From: Roe, Dilan, Env. Health
To: ["Tom Venus"](#)
Cc: [Couch, Shannon L. \(URS\)](#); ["Matt Herrick"](#)
Subject: RE: Fuel Leak Case RO307, Former BP STation #402
Date: Wednesday, January 02, 2013 1:31:00 PM

Thanks for taking the time today to discuss the *Work Plan for Monitoring Well Installation and Vapor Intrusion Assessment* dated October 31, 2012 prepared on behalf of Atlantic Richfield Company by Broadbent. Please revise and resubmit the workplan to address the items discussed including:

Subject: Fuel Leak Case No. RO0000307, Exxon Service Station, 1450 Fruitvale Avenue, Oakland, California

AEI CONSULTANTS	
2500 CAMINO DIABLO, SUITE 200, WALNUT CREEK, CA	
GROUNDWATER ANALYTICAL DATA WITH PROPOSED WELL LOCATIONS	
1450 FRUITVALE AVENUE OAKLAND, CALIFORNIA	FIGURE 5 AEI PROJECT NO. 10460

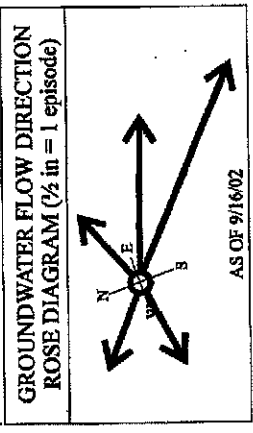
Alameda County Environmental Health Department (ACEH) staff have reviewed the case file and the report entitled, "Work Plan for Monitoring Well Installation", dated March 7, 2005 and prepared on your behalf by AEI Consultants. ACEH has reviewed your request to relocate three monitoring wells MW-5, MW-6 and MW-8. ACEH generally agrees with the revised monitoring well locations as presented in Figure 3, Revised Proposed Monitoring Well Locations.

- 1. Proposed Monitoring Well Locations.** ACEH understands the difficulty with off site encroachment and access issues regarding the installation of groundwater monitoring wells. AEI has revised the location of three proposed groundwater monitoring wells and ACEH concurs with the new monitoring well locations. ACEH suggests the use of monitoring wells designed with screen intervals of 2 feet to 5 feet or less, as these wells will likely be representative of depth discrete groundwater conditions. Please present your conclusions for monitoring well construction in the SWI report requested below.

AEI CONSULTANTS	
2500 CAMINO DIABLO, SUITE 200, WALNUT CREEK, CA	
SITE PLAN	
1450 FRUITVALE AVENUE OAKLAND, CALIFORNIA	FIGURE 2 AEI PROJECT NO. 10460

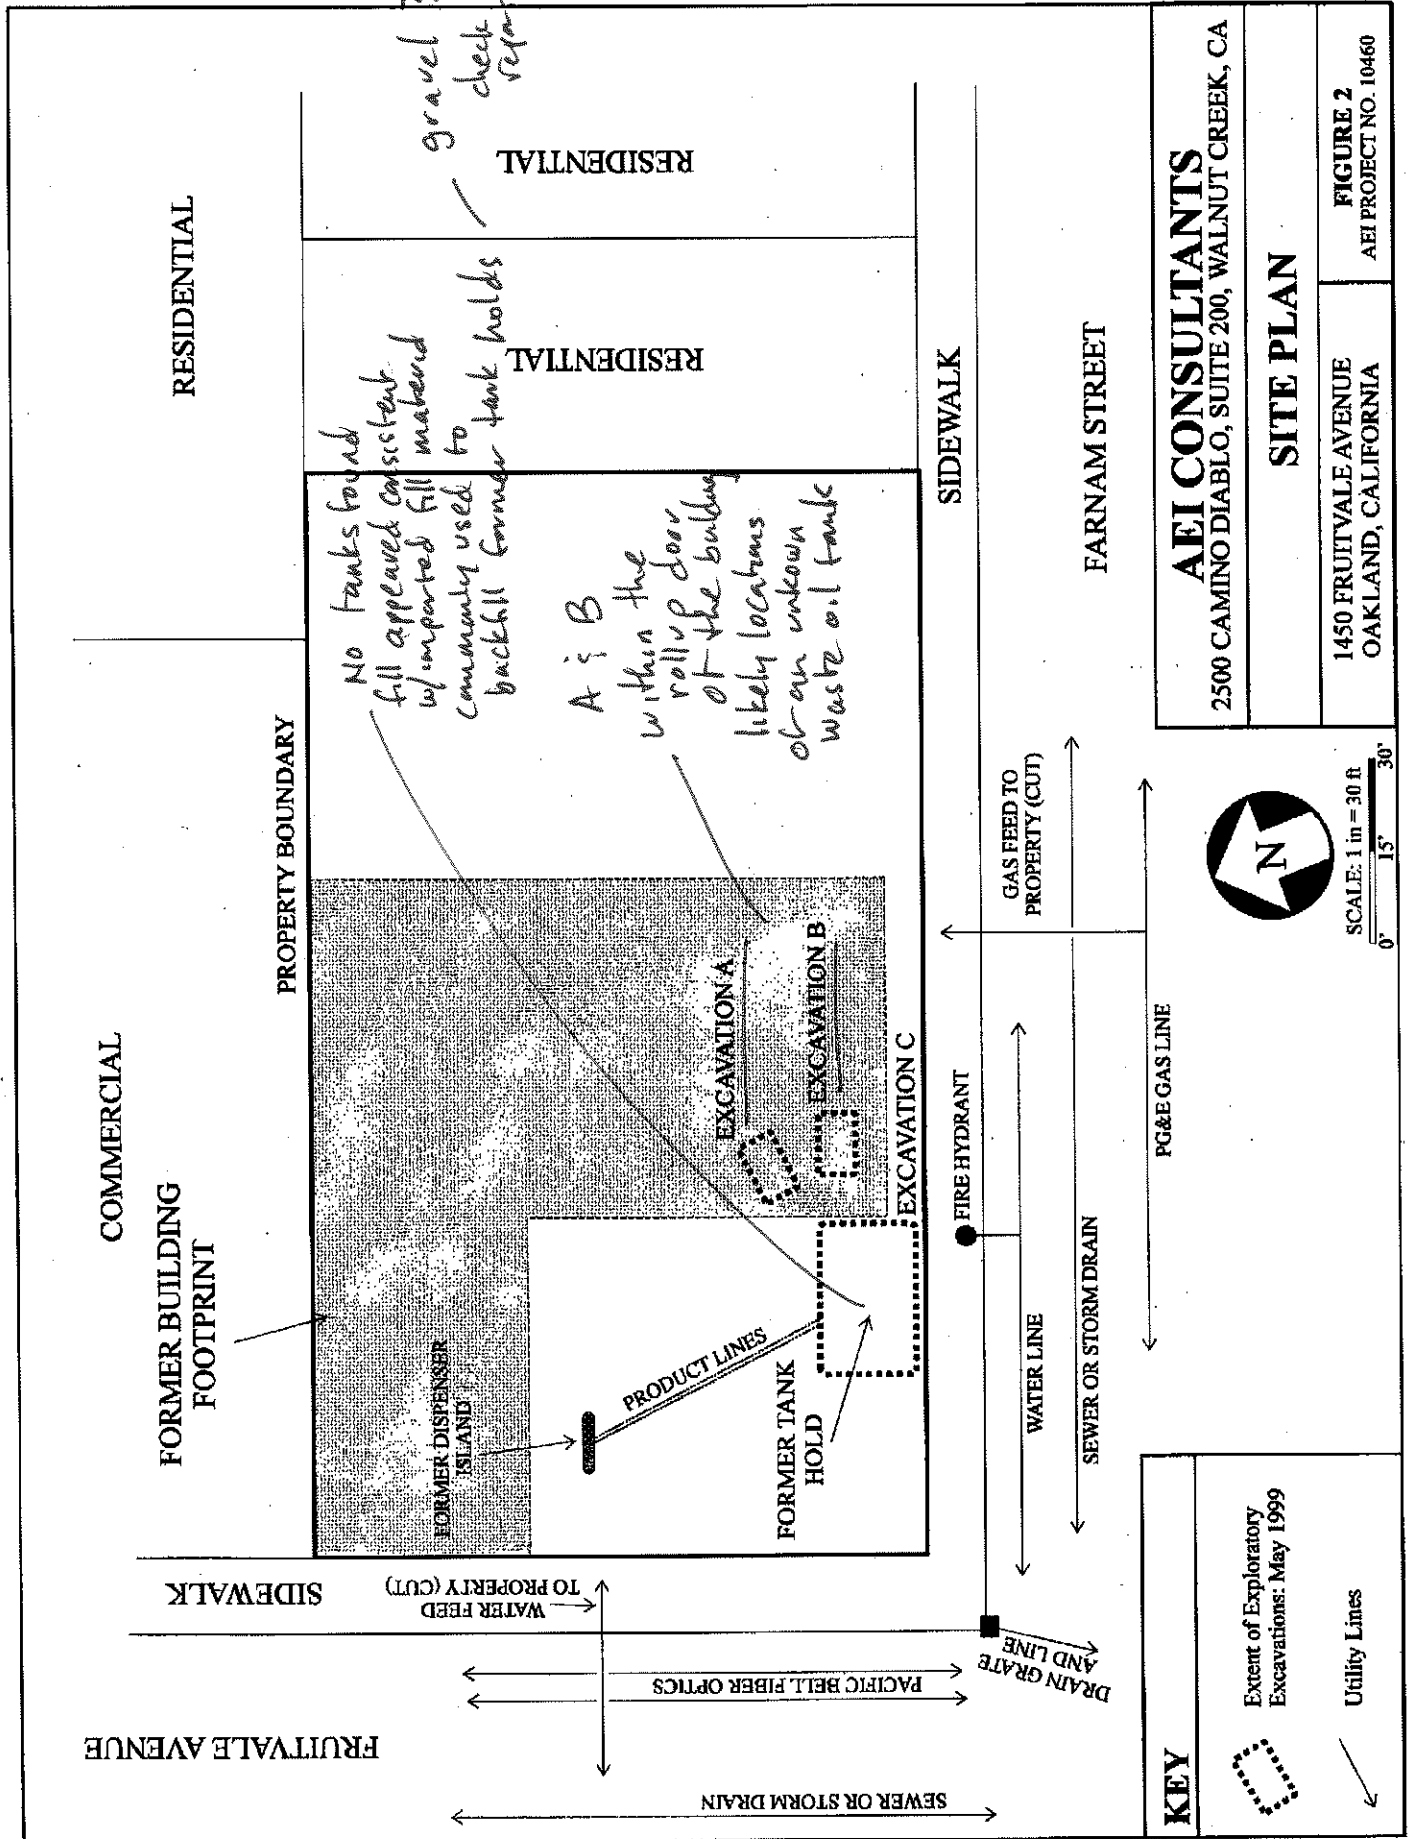
- They need Soil Vapor samplers
- Shorter screened wells ~ 10-15' screen interval for sampling

*No tanks found
fill appeared consistent
w/ imported fill
material commonly used
to backfill former tank holds*

*gravel?
check
reports*

*A & B
within the
roll up door
of the building
likely locations
of an unknown
waste oil tank*

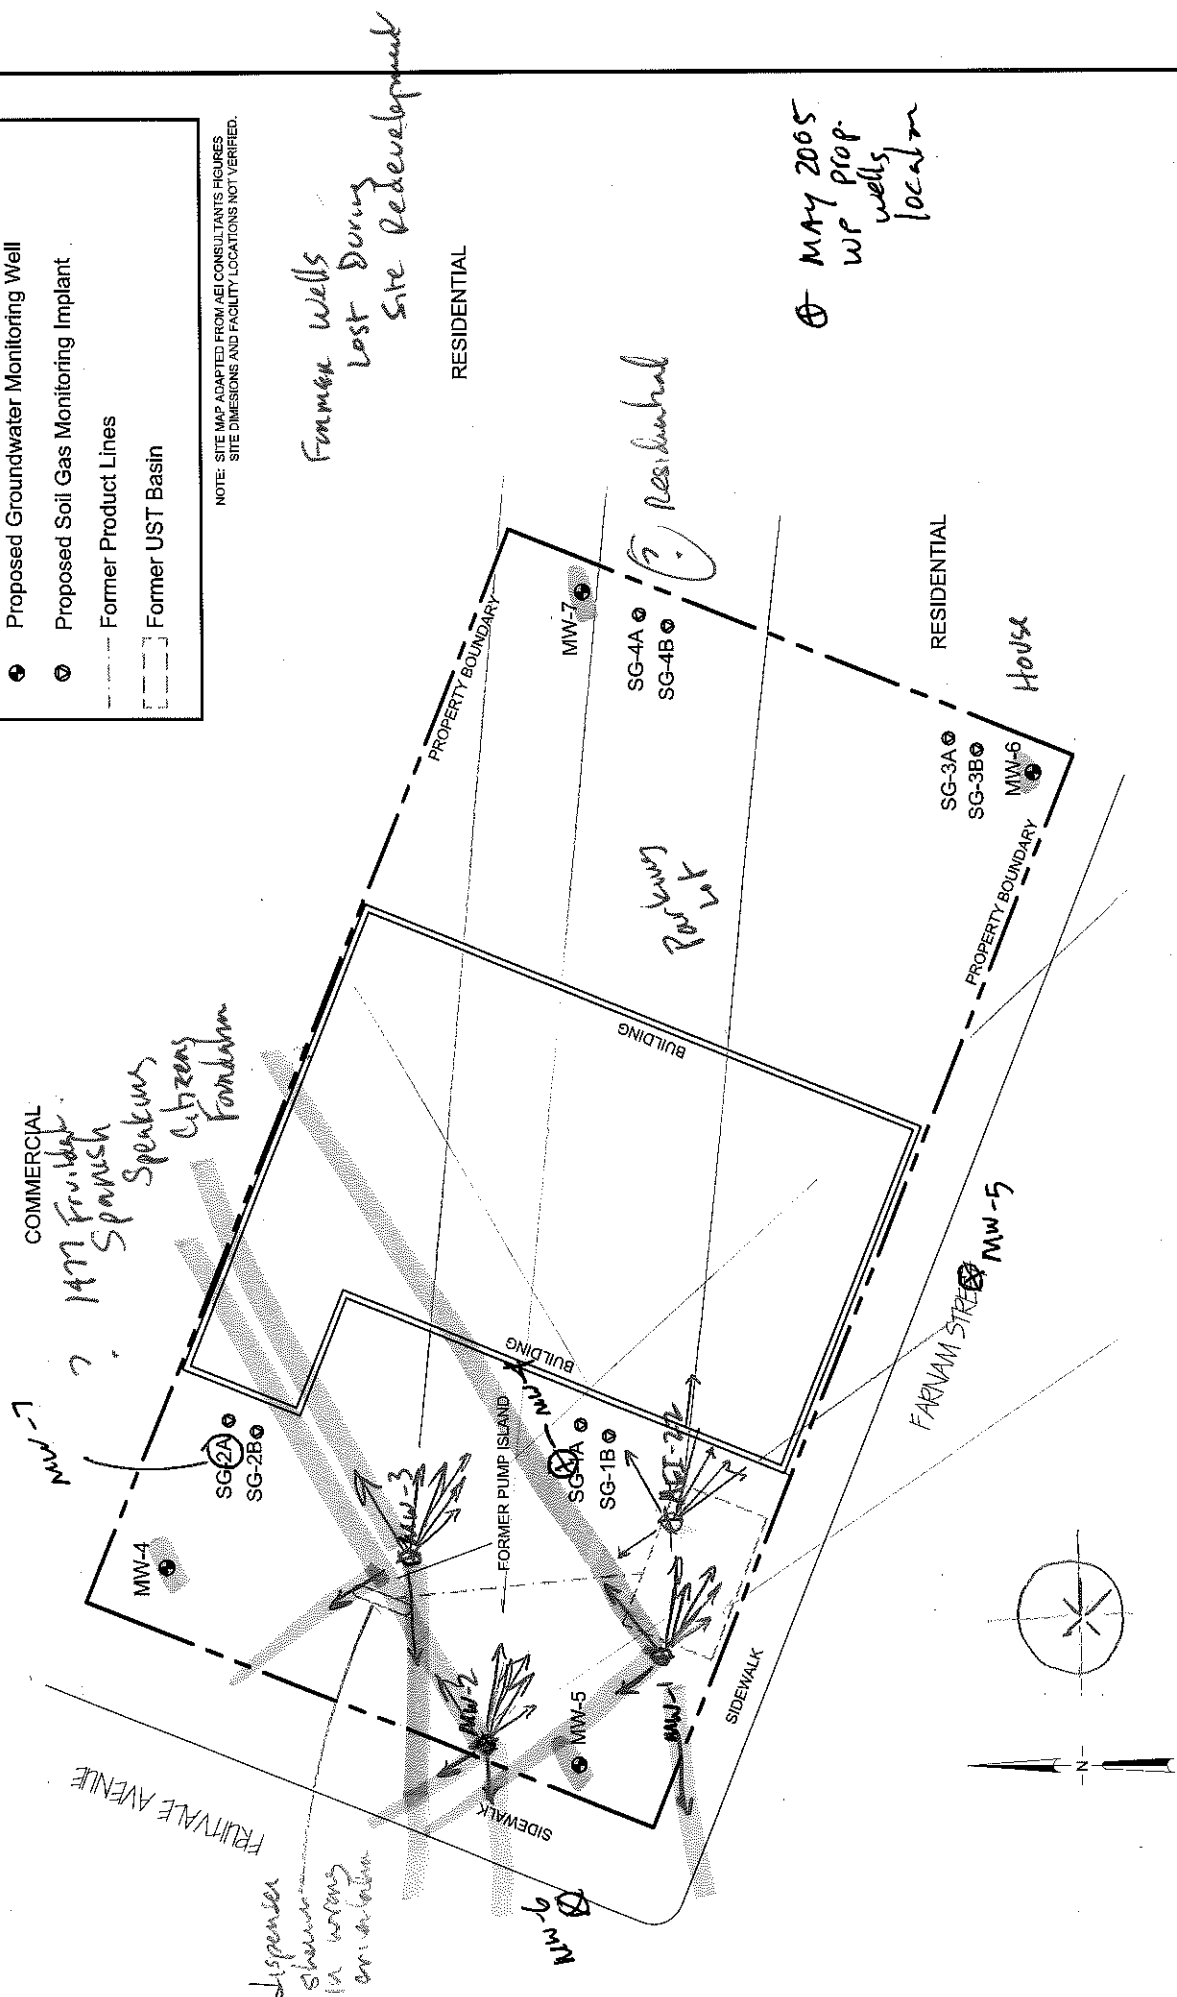
- Rational and justification for proposed location of six groundwater monitoring wells – changes in groundwater flow gradient, access issues, plume delineation, etc. (reference March 7, 2005 proposed locations)
- Rationale and justification for proposed groundwater monitoring well screen intervals – purpose of monitoring (gravel aquifer, clay layers, water table fluctuations, etc). As discussed please consider use of short screen intervals so as to be representative of depth discrete groundwater conditions
- Additional detail on previous attempts to locate monitoring wells MW-1, MW-2 and MW-3 and proposed steps to locate/abandon prior to site closure
- Discussion and reference regarding proposal to collect soil samples at 2 foot intervals until the groundwater table is encountered (but not collect saturated soil samples)
- Revised figures
